RE: Buckingham Compressor Station, Registration No. 21599

The Southern Environmental Law Center offers the following comments on the draft air permit for the Atlantic Coast Pipeline, LLC's ("Atlantic") proposed Buckingham Compressor Station, Registration Number 21599 ("Draft Permit"). These comments are submitted on behalf of the Southern Environmental Law Center, Friends of Buckingham, Natural Resources Defense Council, Sierra Club, Shenandoah Riverkeeper, Potomac Riverkeeper, Shenandoah Valley Battlefields Foundation, Virginia Wilderness Committee, Augusta County Alliance, Shenandoah Valley Network, Highlanders for Responsible Development, the Chesapeake Climate Action Network, Wild Virginia, the Allegheny-Blue Ridge Alliance, and Defenders of Wildlife.

Figure 1: Map of Households Surrounding the Proposed Buckingham Compressor Station

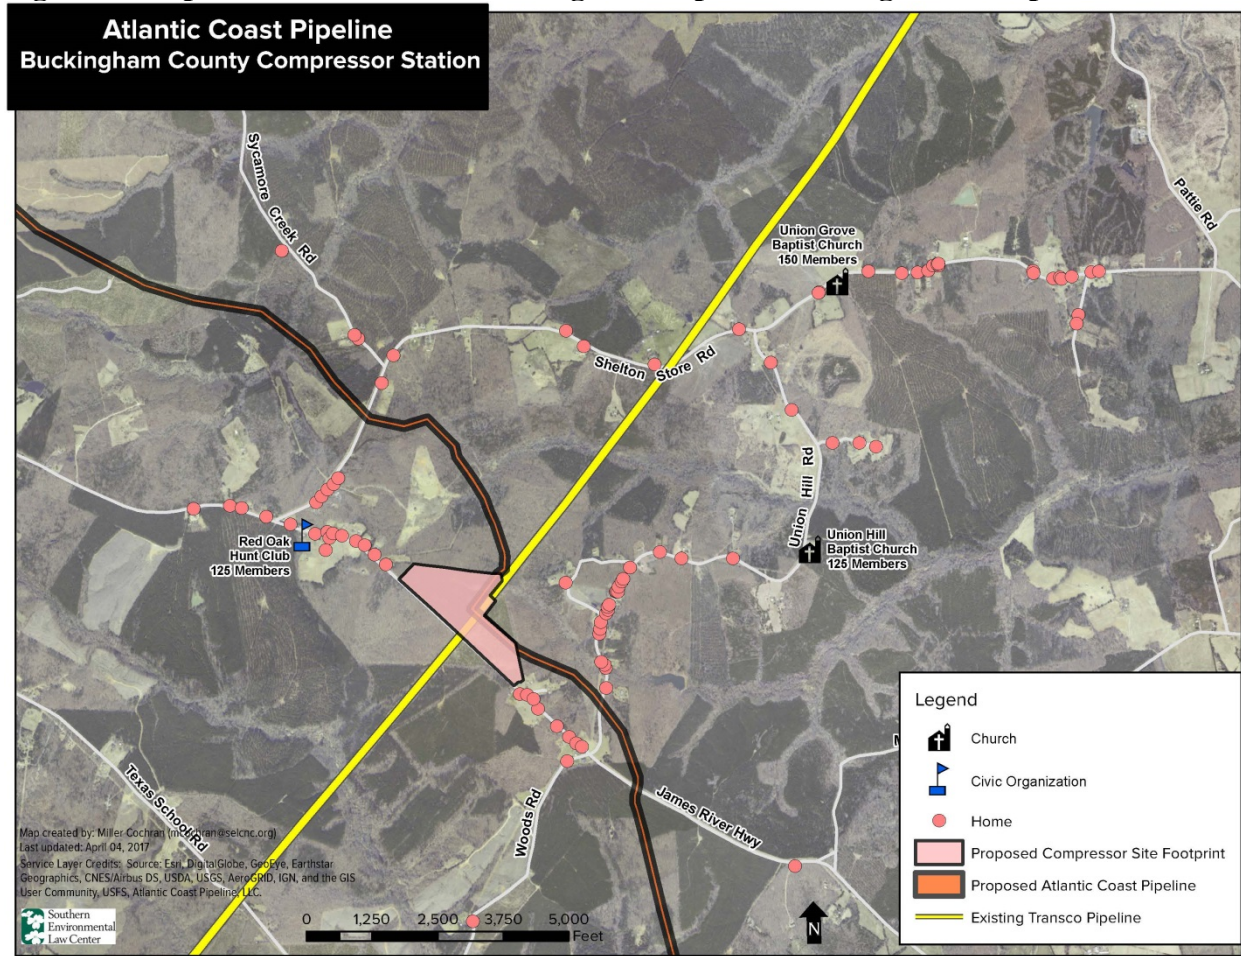
As part of its site suitability analysis, VDEQ determined that the area around the proposed Buckingham Compressor Station is “sparsely populated” and primarily surrounded by forests.⁵⁷ This conclusion is not consistent with the denser than average Union Hill community that inhabits the area within a one-mile radius of the site. To reach this flawed conclusion, it appears that VDEQ relied on Atlantic’s use of countywide population density data of 29.6 people per square mile.⁵⁸ But this county-level population density data does not reflect the actual characteristics of the neighboring community. As noted above, Friends of Buckingham has identified nearly 100 households in the 1.1 mile radius of the proposed compressor stations. The 75 households surveyed to date are made up of 199 residents.

As seen in Figure 1 below, there are significant clusters of households in the area surrounding the proposed compressor station:

This disparity is significant, and the large number of households that in fact lie close to the proposed compressor station contradict VDEQ’s site suitability conclusion that the area around the Buckingham compressor station is primarily surrounded by forests and sparsely populated. The Air Board must independently consider the unsuitability of this proposed location for a new source of industrial air pollution.
